CITY OF MADISON
CITY ENGINEERING DIVISION
DEPARTMENT OF PUBLIC WORKS
PLAN OF PROPOSED IMPROVEMENT

N FRANKLIN AVENUE & LYNN TERRACE -
ASSESSMENT DISTRICT 2025
CITY PROJECT NO. 15113
CONTRACT NO. 8766

ADDENDUM 1 - 02/11/25
UPDATED SHEETS: D5-D10,
PD1-PD5, P1-P6, X1-X13

REVISION 1 - 04/03/25
UPDATED SHEETS: COVER,
D6, PD1-PD3, P1-P3, U1-U9,
W1-W9, X3-X11
SHEET ADDED: U10

NAME		DATE		TIME		REVISION		DATE		BY	
REV3		UPDATED CURB & PYMT LIMITS						09/02/25		GIT	
ADD1		UPDATED CL PROFILE						02/11/25		GIT	
MARK											
Designed By: GJIT						Date: 9/2/2025 8:34 AM		Scale: 1" = 40'			
15113										P-5

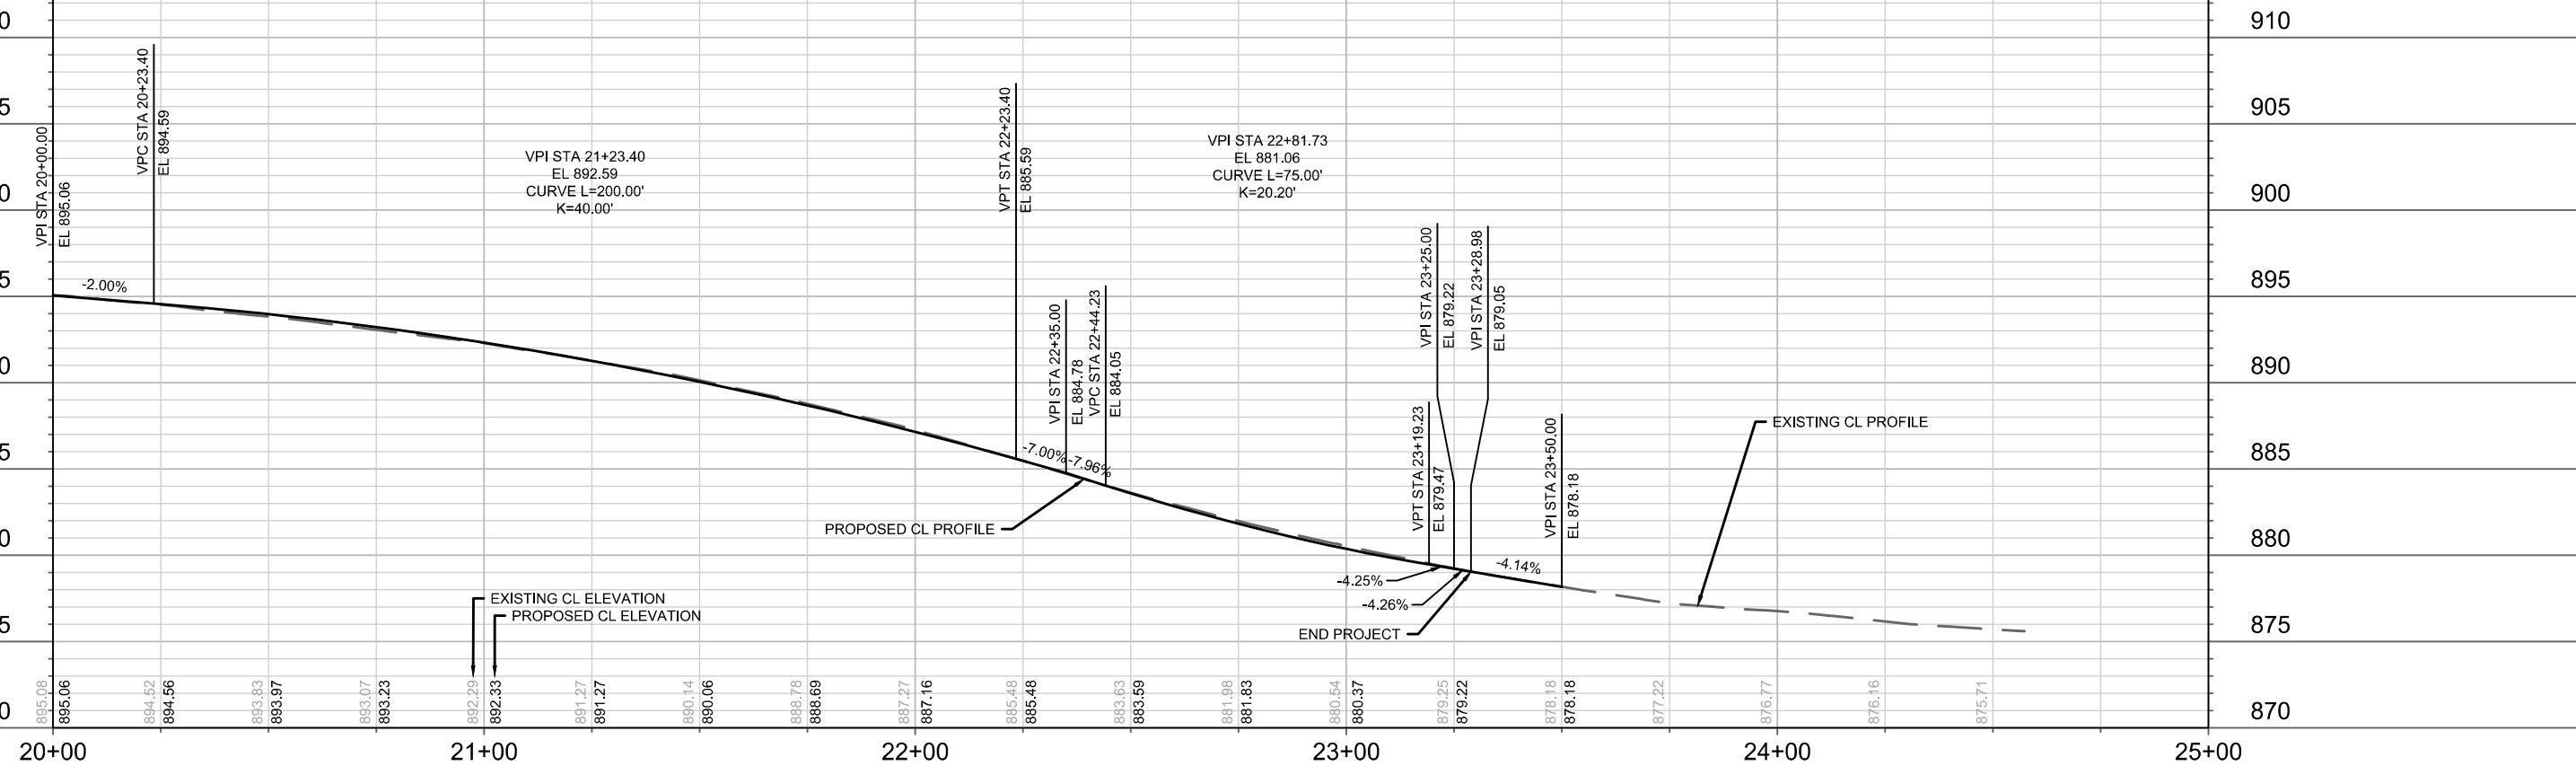
ADDENDUM 1 - GCIT - 02/11/25
- UPDATED CL PROFILE

MARK		REVISION		DATE	BY
15113	Designed By: TDP	Date: 4/3/2025	10:27 AM		W-6

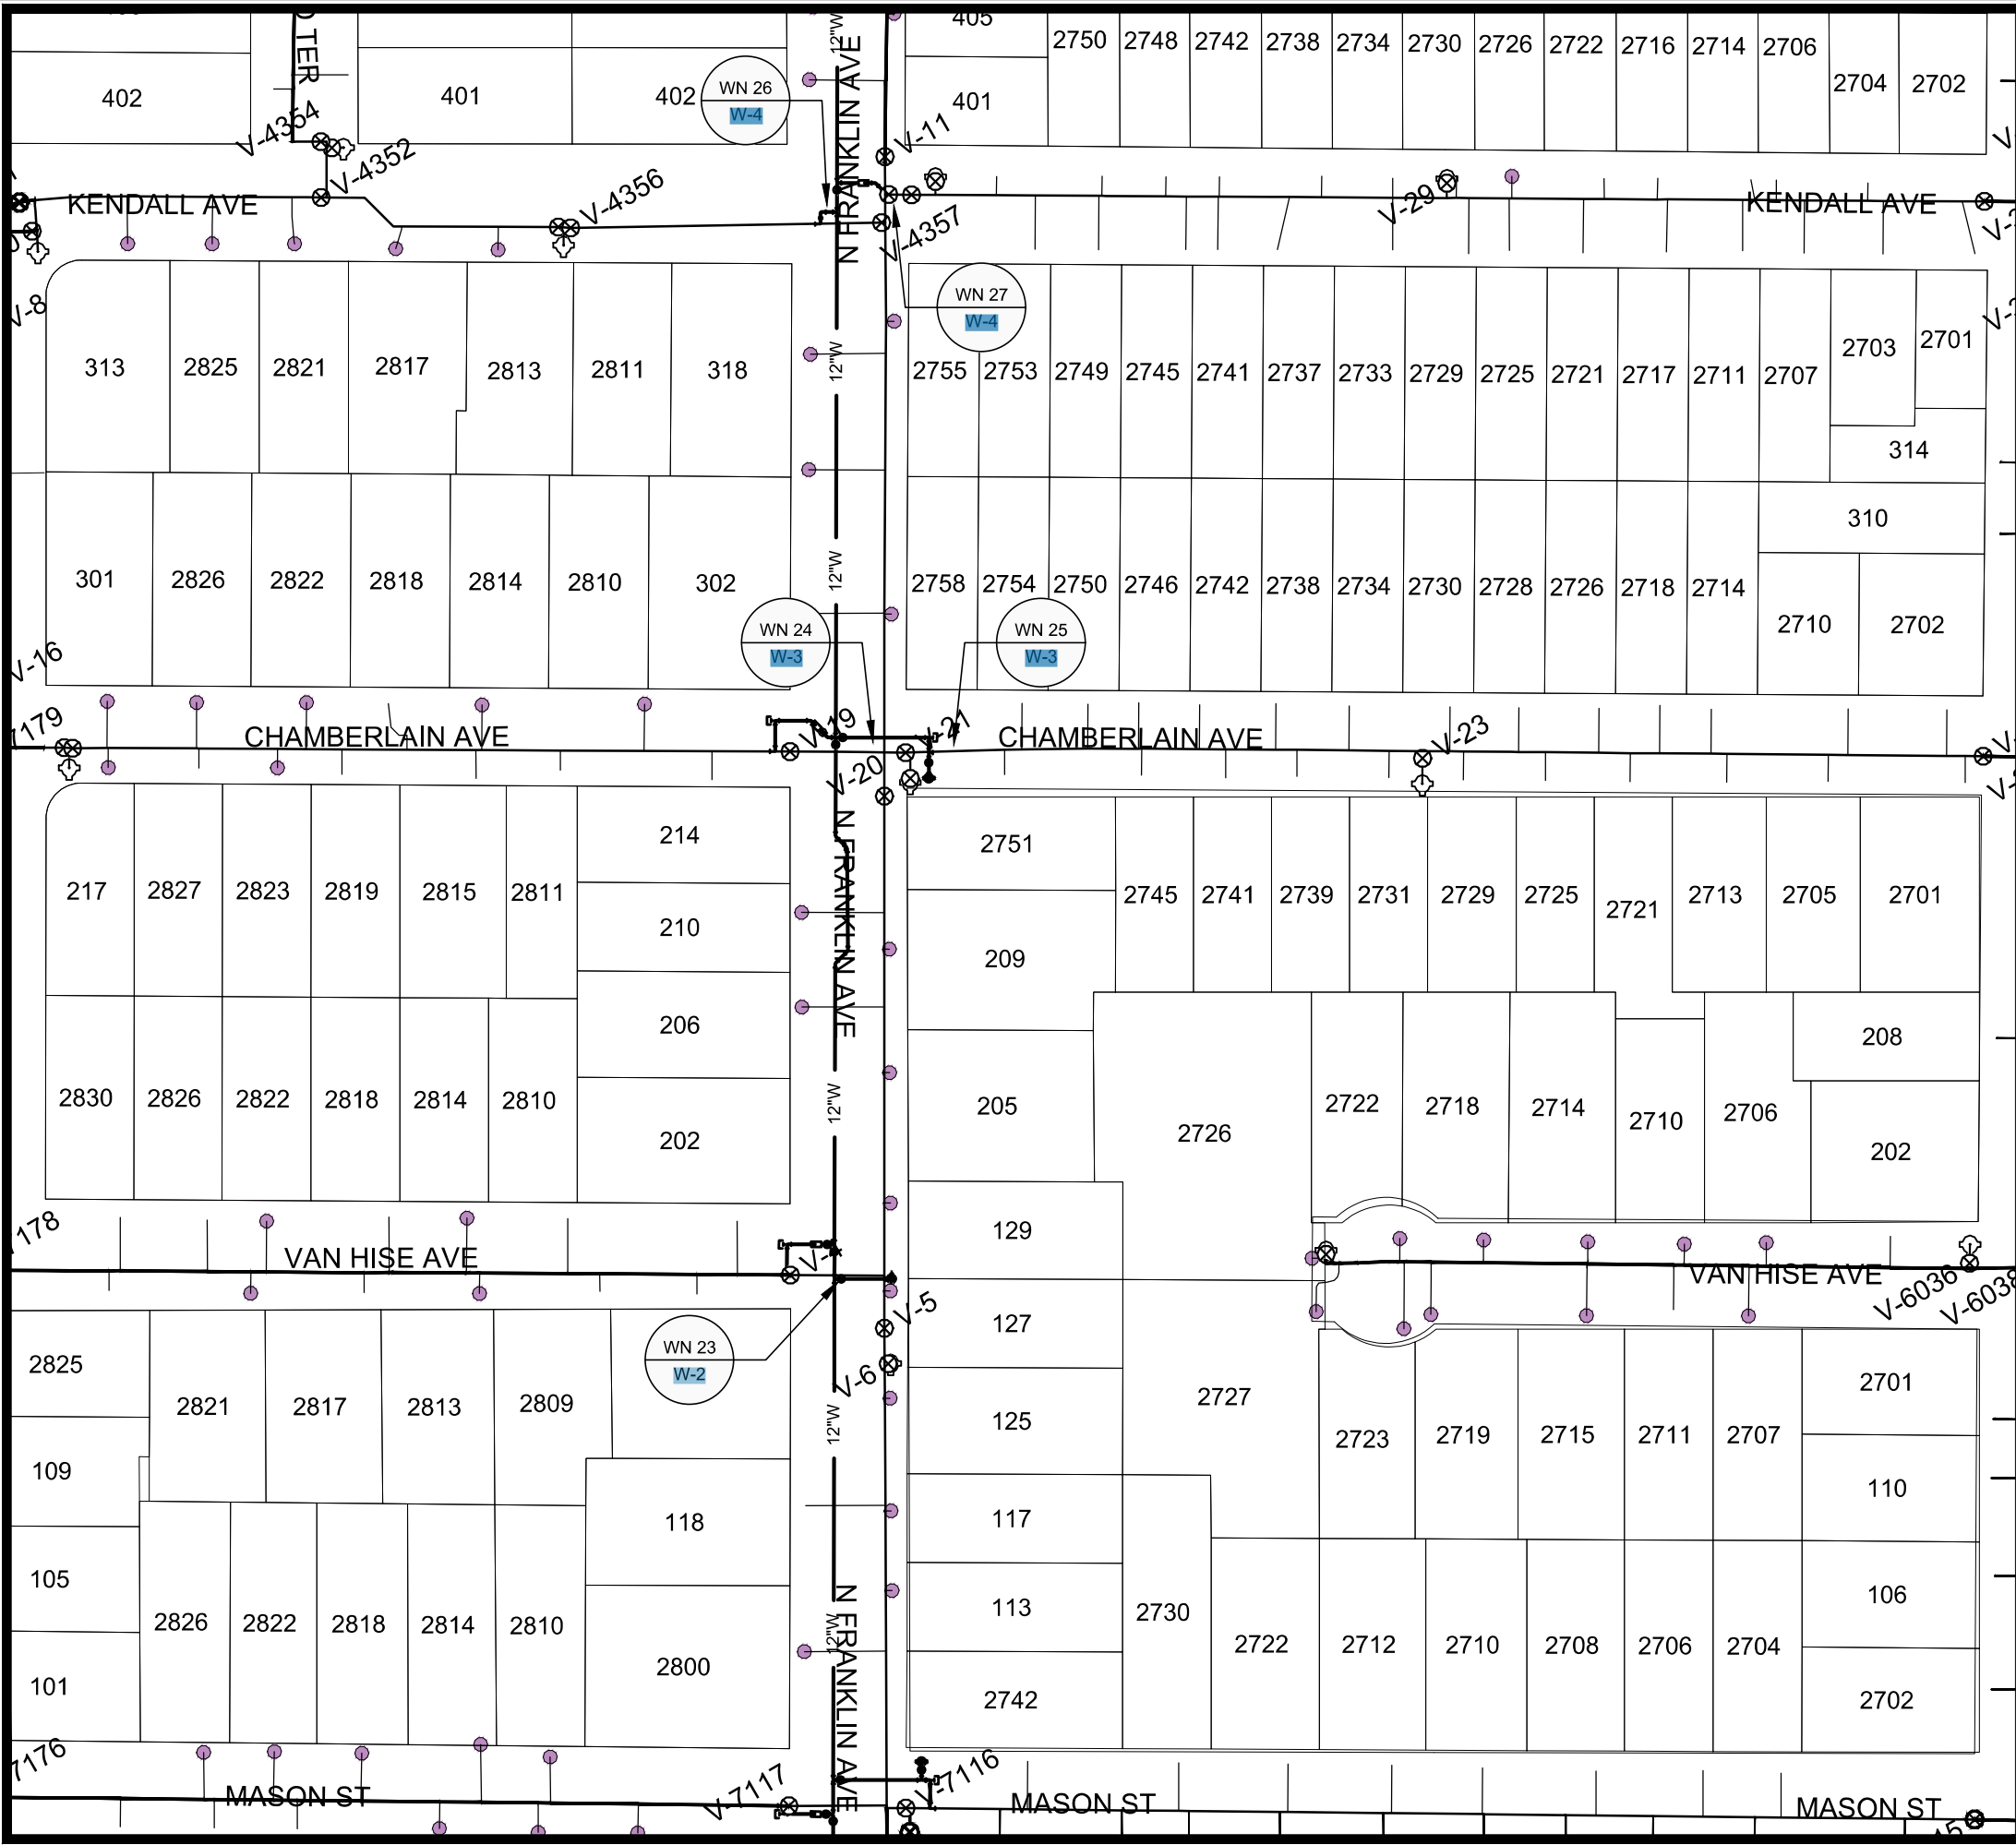
REVISION 1: TDP 4/3/25
UPDATED IMPACT PLAN FOR CONNECTION AT REGENT ST INTERSECTION

REV1	UPDATED CROSS SECTIONS	04/03/25	GCIT
ADD1	UPDATED ELEVATIONS	02/11/25	GCIT
DATE	DATE	DATE	BY
DESIGNED BY: GCIT	DATE: 4/3/2025	10:41 AM	SCALE: 1" = 20'
15113			X-7

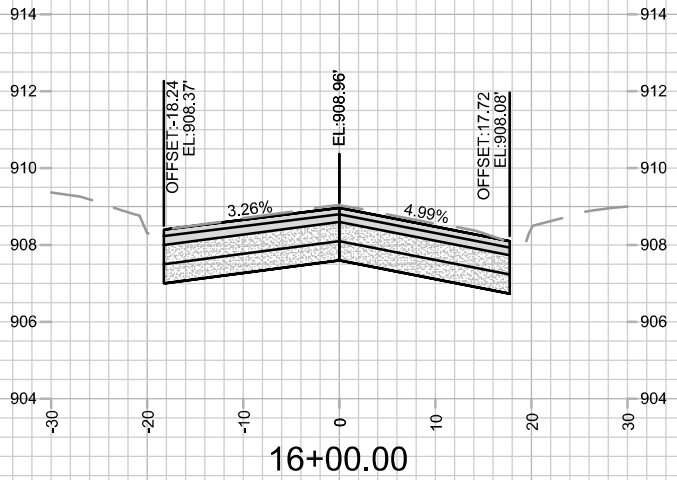
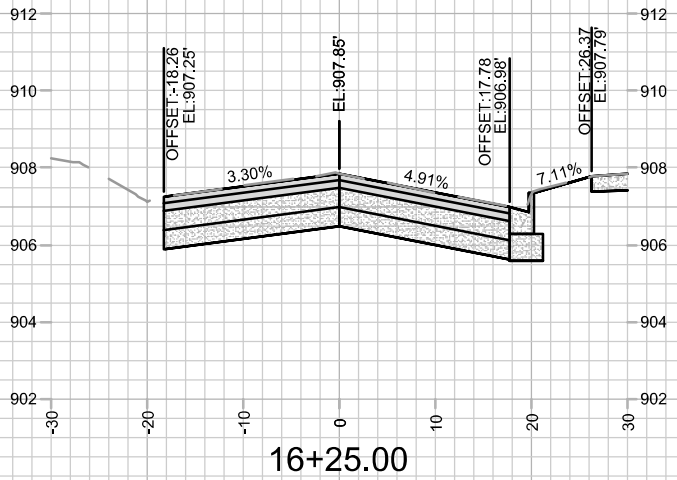
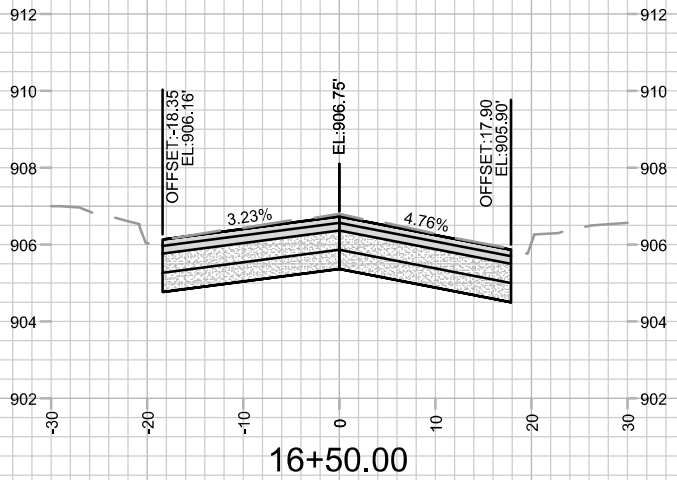
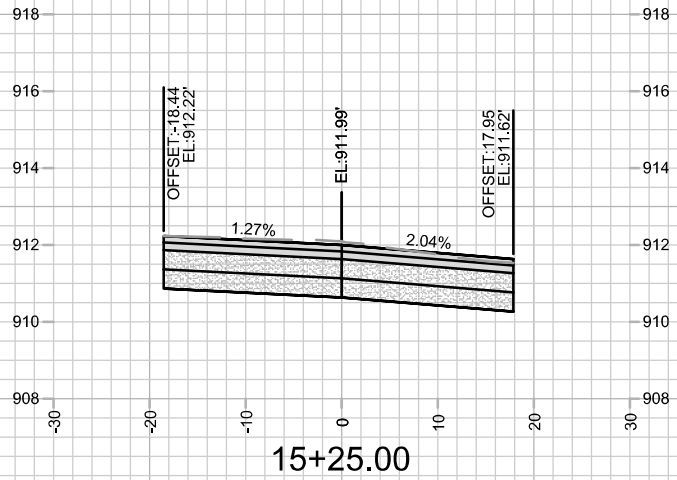
ADDENDUM 1 - GCIT - 02/11/25
- UPDATED CROSS SECTIONS WITH NEW CL
PROFILE ELEVATIONS

REVISION 1 - GCIT - 04/03/25
- CROSS SECTIONS SHIFTED DUE TO THE ADDITION
OF THE CROSS SECTION FOR STA 8+25.00
